Appl. No. : 09/881,256
Filed : June 14, 2001

Discussion of Drawing Corrections

Proposed Drawing Correction

FIG. 1

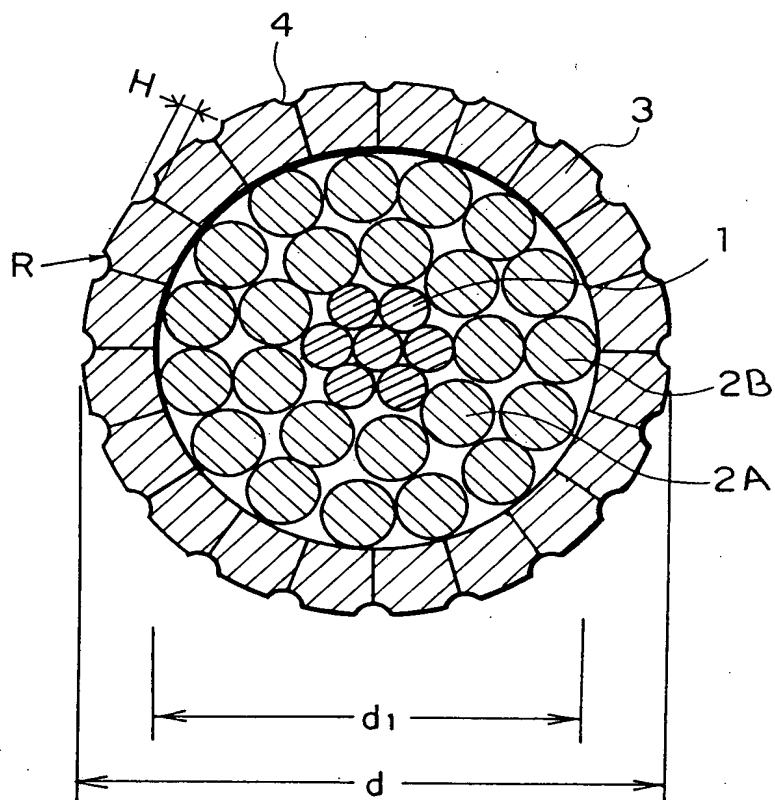
Applicant has amended Figures 1 and 2 to clarify the position of reference signs "2A" and "2B" that are mentioned in the specification.
